PLANNING AND ACCESS COMMITTEE

MEETING: NPA/PC/07/2014

REPORT No.	NPA/PC/07/2014/04
SUBMITTED BY:	Director of Operations
APPLICATION NUMBER:	2012/0064/DET
APPLICANT:	Harley Developments
LOCATION:	Scout Hall, Buchanan Place, Callander
PROPOSAL:	Erection of 4 No. flatted dwellings

Site Plan

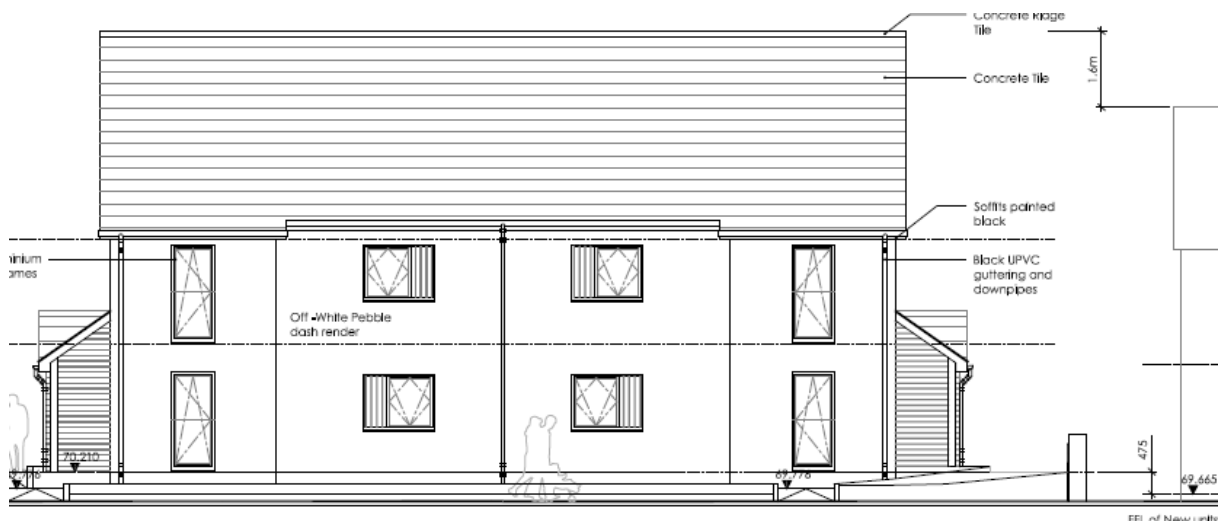
In terms of siting, the building is to follow the front street building line of the existing dwellings to the west. The rear building line will not project as far towards the riverbank as these existing dwellings. The rear of the site fronts a path and the river bank. A mature hedge defines the boundary between the open space along the river bank and the site. The existing hedge along the rear site boundary is proposed to be removed to allow the re-development of the site however a new hedge will be planted post construction. In a similar pattern to existing development in the locality, parking will be provided to the front.

Proposed Elevation Fronting Buchanan Place

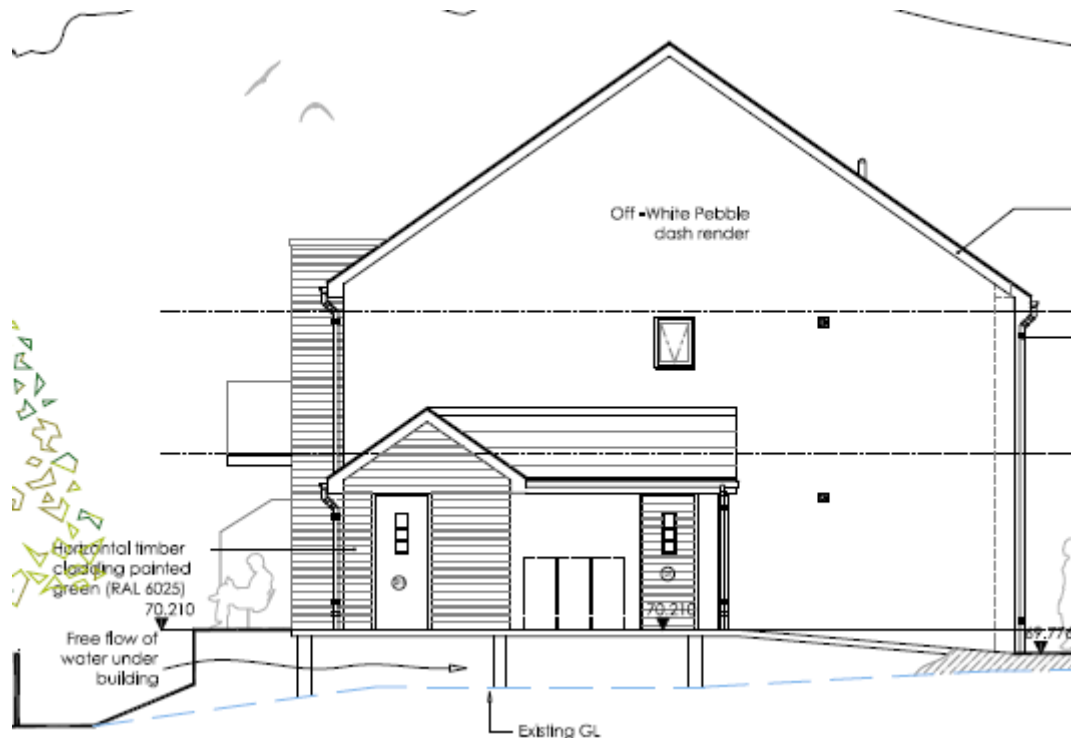
In accordance with the advice of Stirling Council Flood Officer the finished floor level of the flats has been raised to 70.210AOD, an increase in 0.545metres relative to the adjacent dwellings. The building would be constructed on raised steel legs. Due to the fact the site

slopes from north to south, the visual impact of this design (in terms of undercroft) will be most significant to the riverside elevation. To soften this impact an area of raised decking is proposed to the rear and a new hedge proposed along the rear boundary. Whilst the decking area is located some 5 metres from the western boundary, to protect the privacy of the adjacent dwelling a condition requiring a suitable screen fence (or alternative) along part of the western boundary is recommended.

- 8 Flooding:** The finished floor level of the building hereby approved shall be set at 70.21mAOD. The building hereby approved shall be constructed using flood resilient materials and construction methods (inclusive of a non-return valve on foul and surface water discharge), details of which shall be submitted to, and agreed in writing by, the Planning Authority prior to the commencement of development. For the avoidance of doubt, there shall be no landraising.
